CONTRACT 2007.07
MAINE TURNPIKE AUTHORITY
ADMINISTRATION BUILDING

CONTRACT 2007.07
MAINE TURNPIKE AUTHORITY
ADMINISTRATION BUILDING
SET 2 OF 2

AS BUILT
Owner Copy

A1 THIRD FLOOR FRAMING PLAN
1/8" = 1'-0"

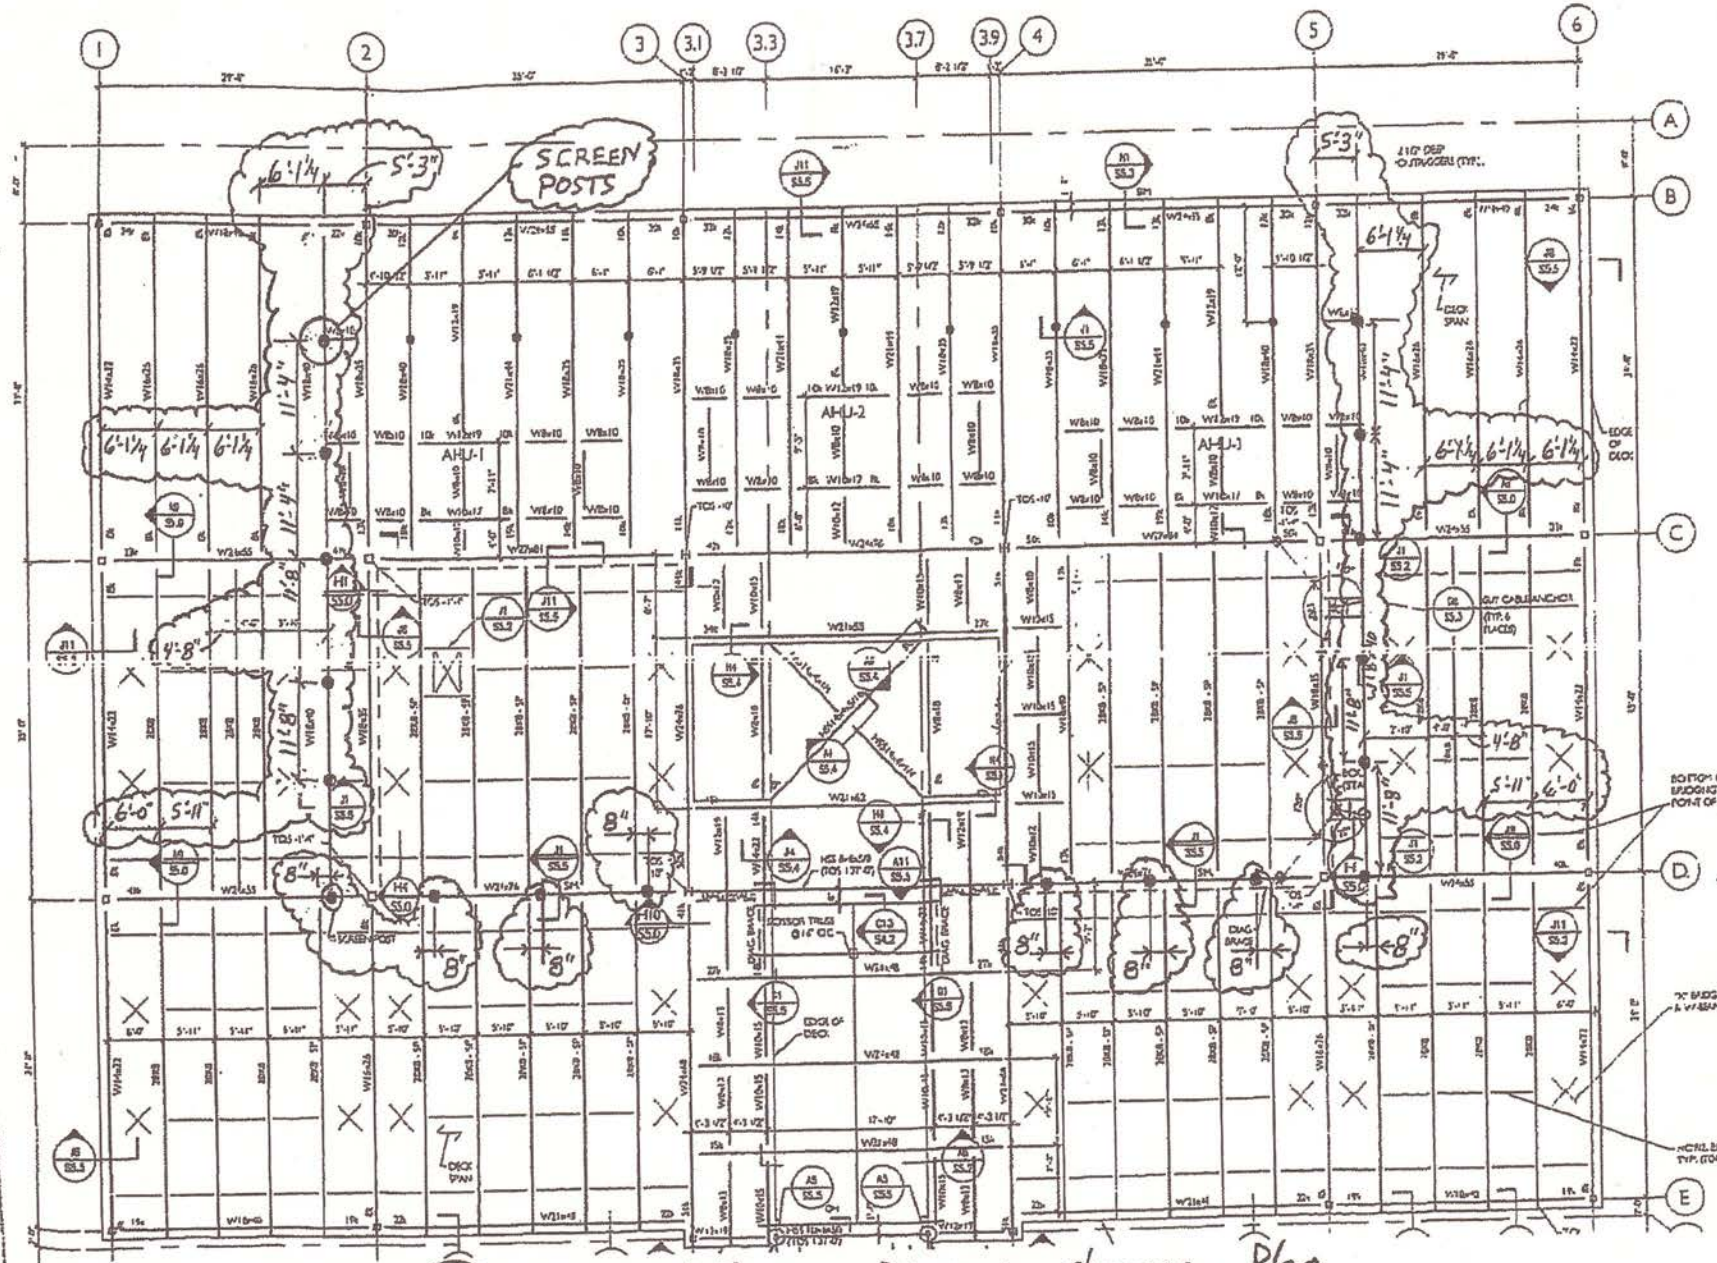
Response to RFI #77 - Relocate screen posts and framing at clouded locations as shown. Beam sizes and other items to remain unchanged.

H7 BRACING ELEVATION AT LINE 5

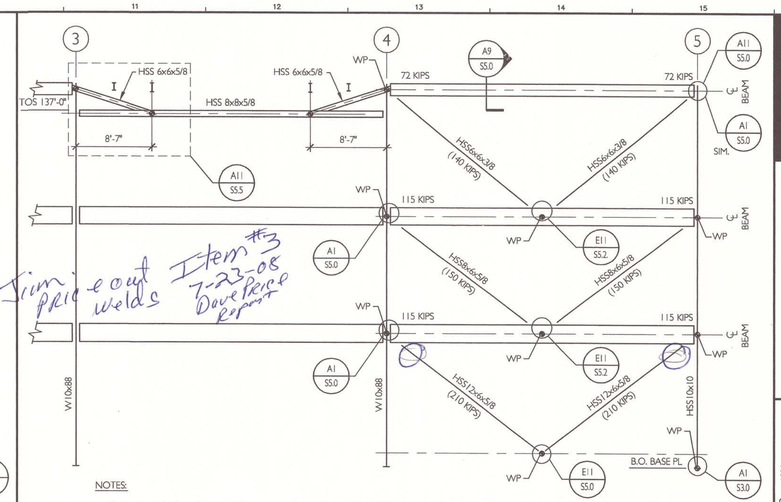
Jim price out Item #3 7-23-08 Dave Price report welds

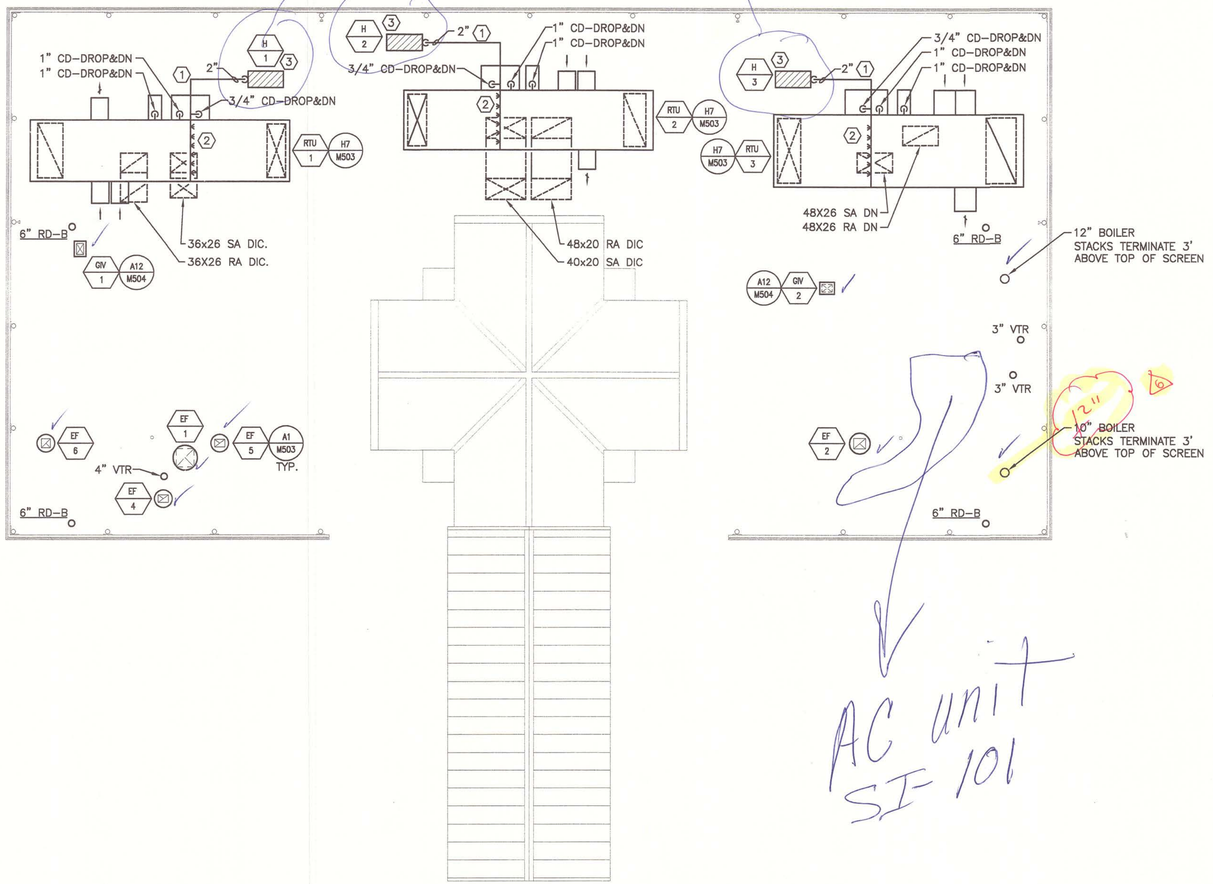
See RFI 268 Humidifier Tank

F1 COMPUTER ROOM CHILLER SCHEMATIC

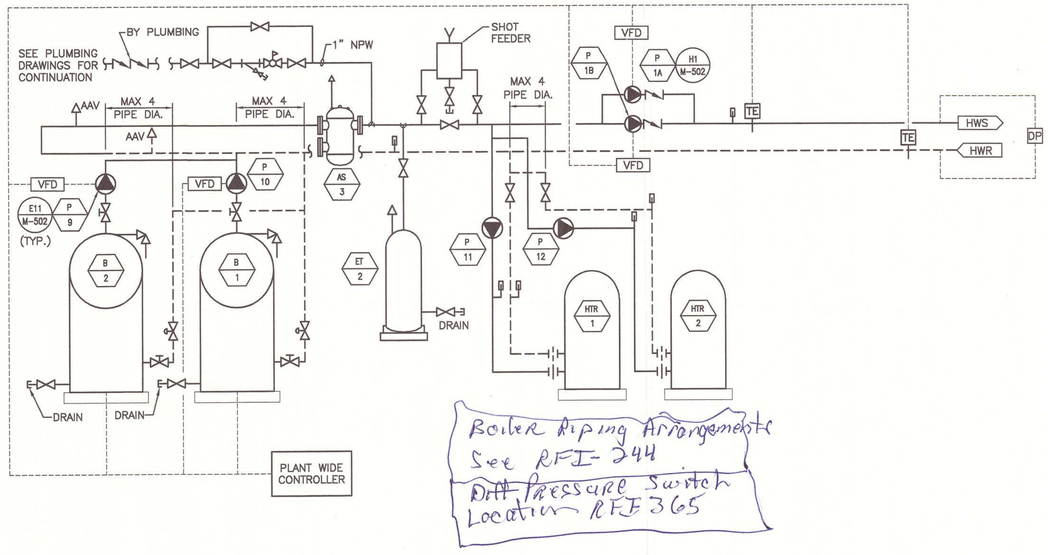
Boiler Piping Arrangement
See RFI-244
Diff Pressure Switch Location RFI 365

A1 HUMIDIFIER CONNECTION DETAIL

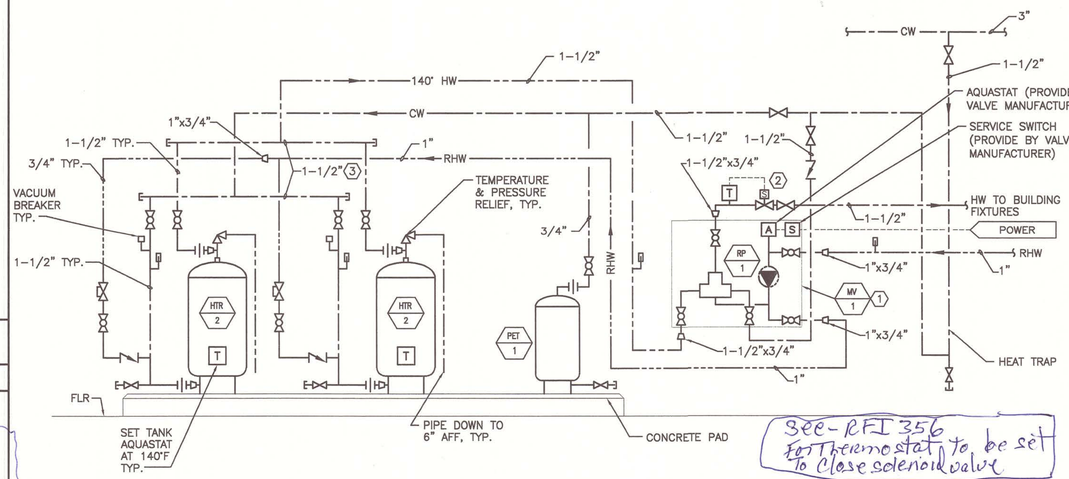
See RFI-356 For Thermostat to be set to Close solenoid valve

A1 DUCTBANK DETAIL

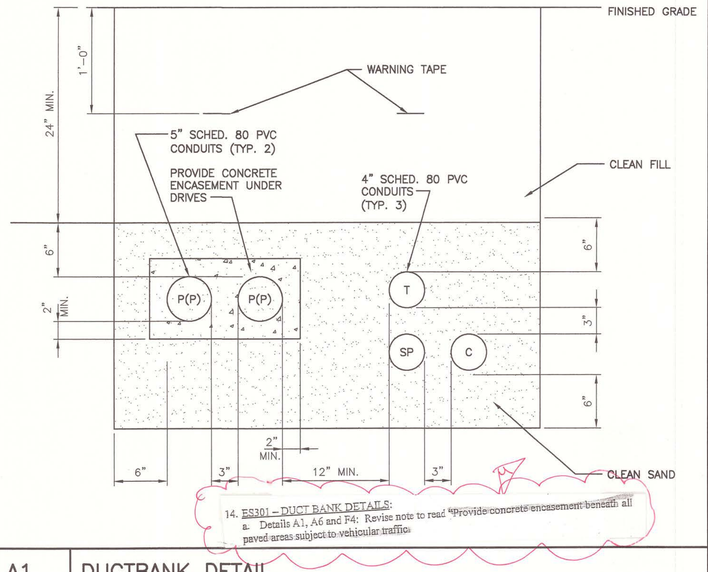
14. ES301 – DUCT BANK DETAILS:
a. Details A1, A6 and F4: Revise note to read "Provide concrete encasement beneath all paved areas subject to vehicular traffic.

A1 DUCTBANK DETAIL

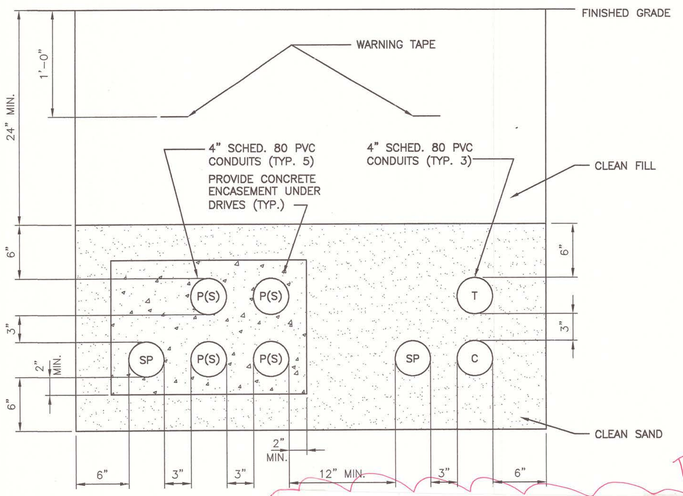
15. ES302 – DUCT BANK DETAILS:
a. Detail A1: Revise note to read "Provide concrete encasement beneath all paved areas subject to vehicular traffic, including paved drives and parking areas."

A9	NETWORKED LIGHTING CONTROL PANEL SCHEMATIC RISER DIAGRAM
NOT TO SCALE

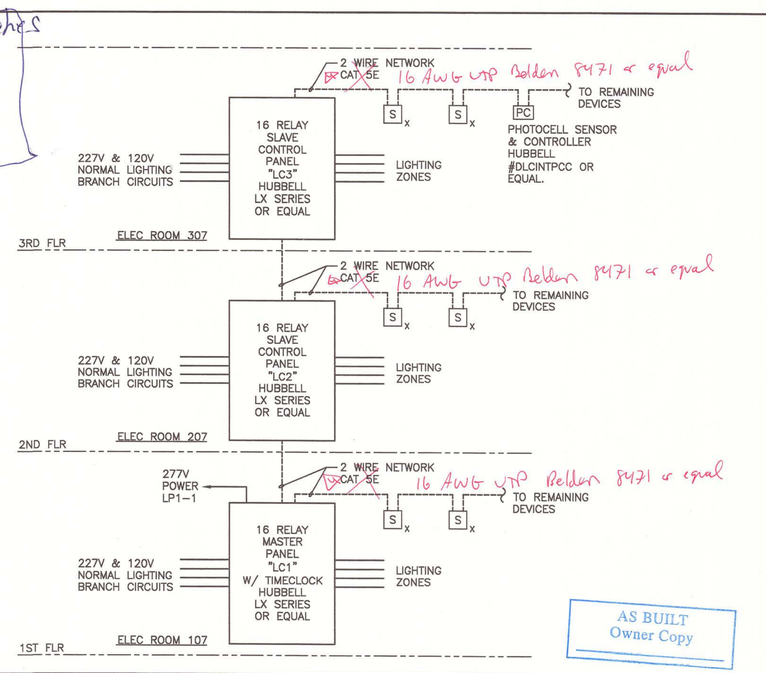
Program FOR Lights + Switches see SI-87

EY103 - THIRD FLOOR SYSTEMS PLAN:

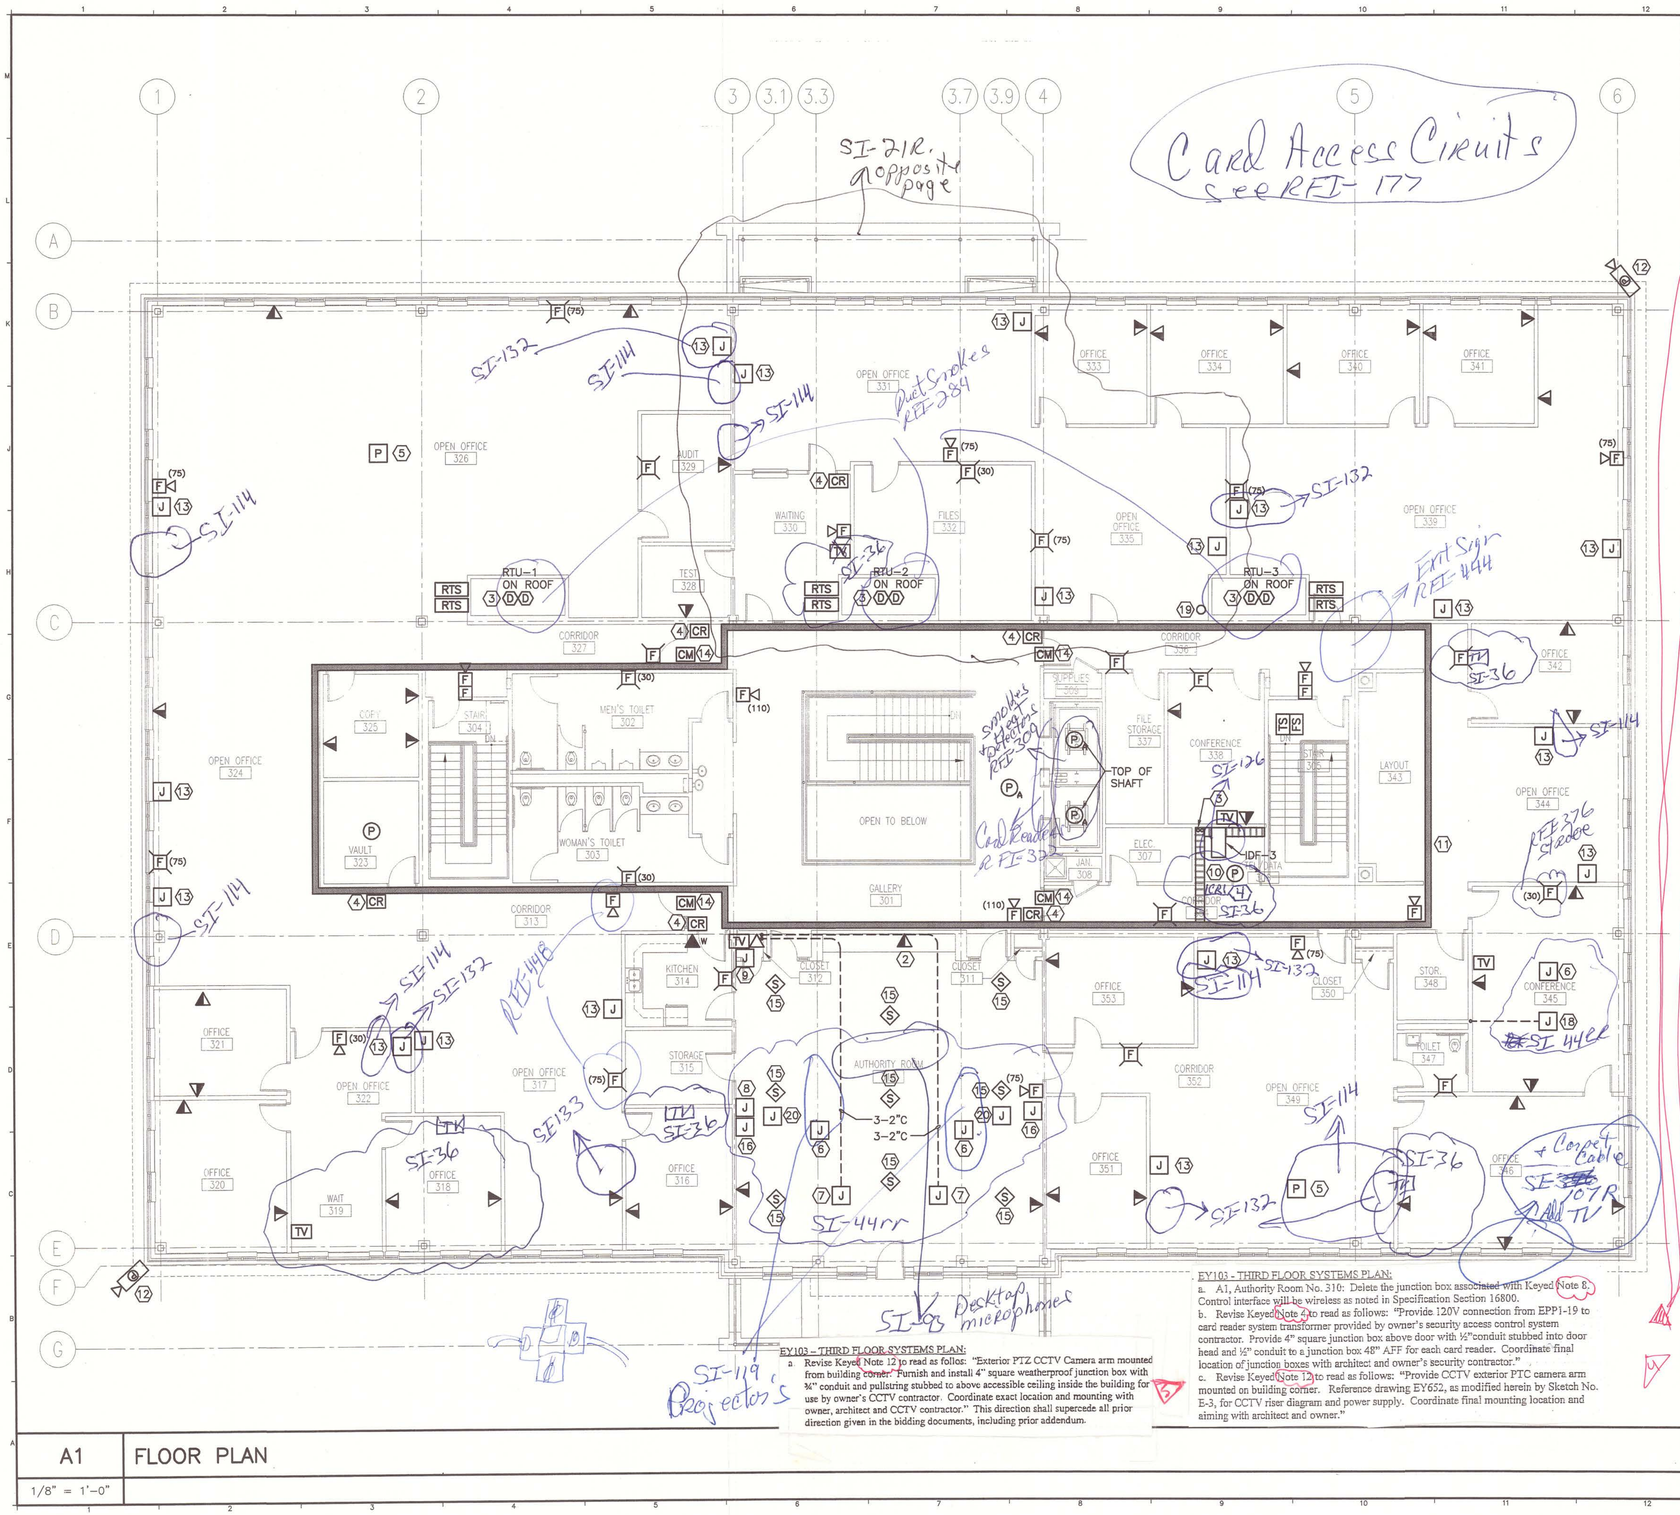
a. Revise Keyed Note 12 to read as follow: "Exterior PTZ CCTV Camera arm mounted from building corner. Furnish and install 4" square weatherproof junction box with ¾" conduit and pullstring stubbed to above accessible ceiling inside the building for use by owner's CCTV contractor. Coordinate exact location and mounting with owner, architect and CCTV contractor." This direction shall supercede all prior direction given in the bidding documents, including prior addendum.
